Application Ref: NP/21/0172/TPO

Case Officer	Mike Higgins		
Applicant	Mr Hopkinson, The Beach Court (Saundersfoot Management Co Ltd)		
Agent	Mr Paul Cleaver, Tree Consultants Wales		
Proposal	Fell 1x Monterey cypress (<i>Cupressus macrocarpa</i>) to ground level, leaving stump in situ. (T12 on TPO 33, wrongly identified as a Douglas Fir)		
Site Location	Beach Court, The Strand, Saundersfoot, Pembrokeshire, SA69 9EU		
Grid Ref	SN13790502		
Date Valid	10-Mar-2021	Target Date	16-Jun-2021

Item 5 - Report on Planning Applications

Image No 2. British Geological Survey data for area

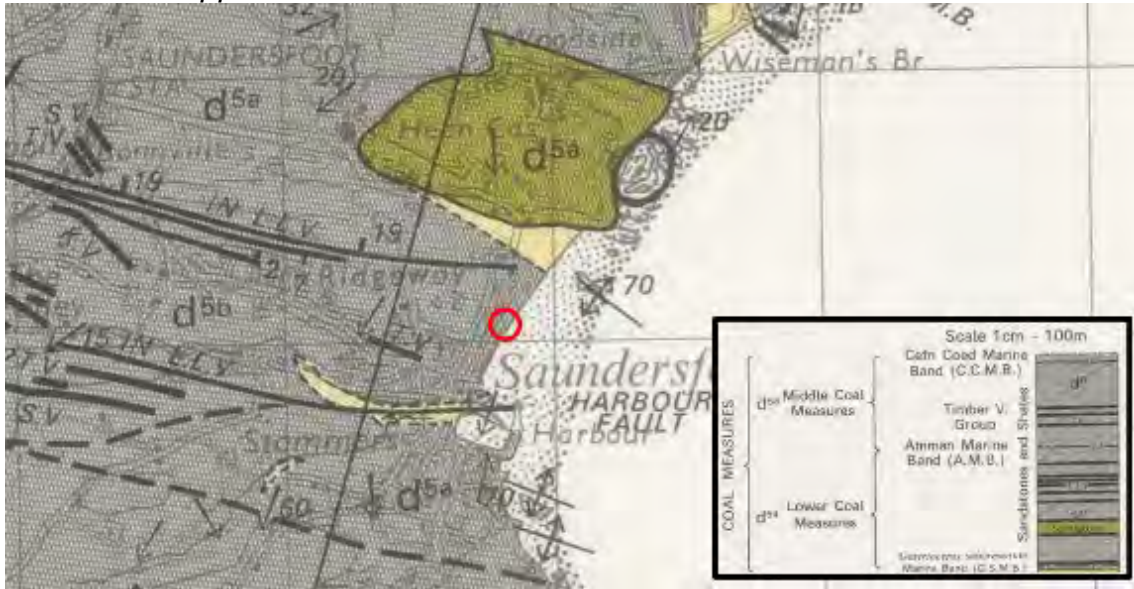
The tree has a locally relevant history and is recognised as a prominent tree which appears to be situated on an exposed outcrop of Middle Coal Measures (*Image No.2*) which is both historically and geologically significant in terms of the industry of the area.

Were the tree to be retained for the medium-long term; it is likely that a geotechnical assessment of the outcrop would be required to understand the constraints posed by the outcrop. The outcrop is composed of Middle Coal Measures (Image No. 2) and

site visits have shown the material directly below the tree to be relatively friable, with a more resilient layer of material at the eastern end of the outcrop (Image No. 3).

Image No. 4 – Land registry

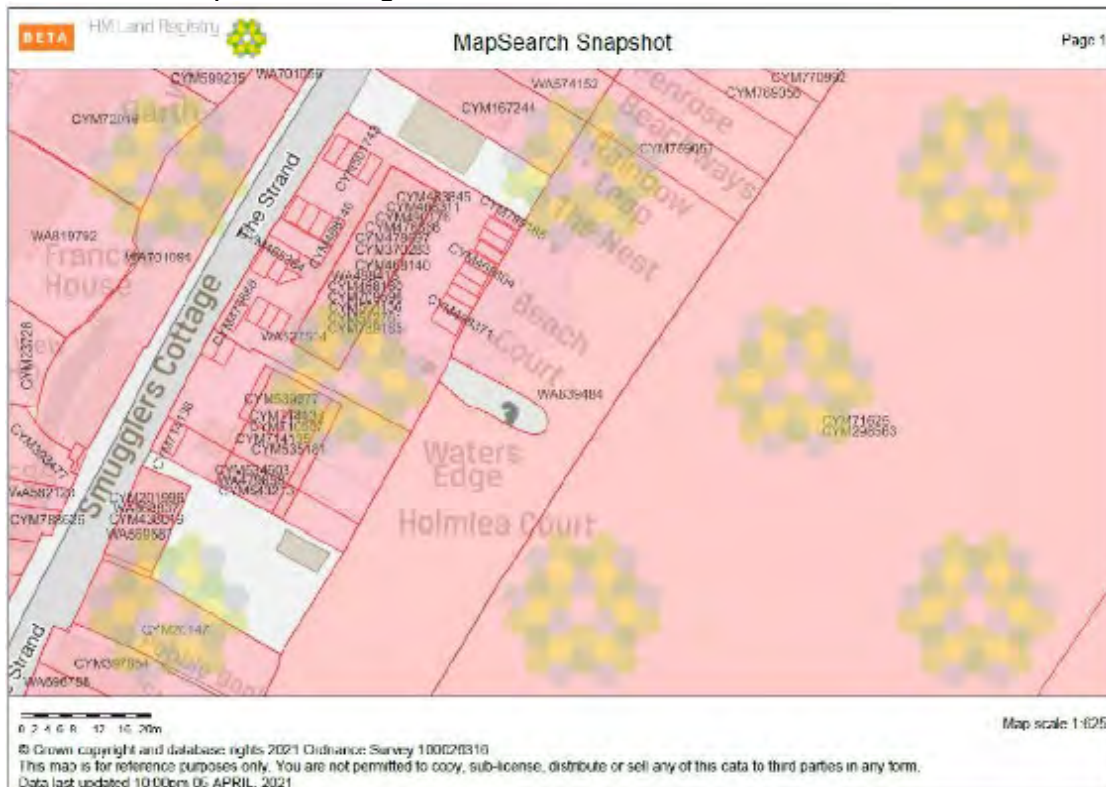
The section of the outcrop that the tree is located on is unregistered (Image No 4.) and as such is not under definable ownership.

A land registry search identified that a section of the outcrop is within the ownership of the Beach Court development (Image No. 4). This issue was raised with the agent for Beach Court; who has confirmed that the tree lies outside the boundary of the property, in the area of the outcrop that is unregistered.
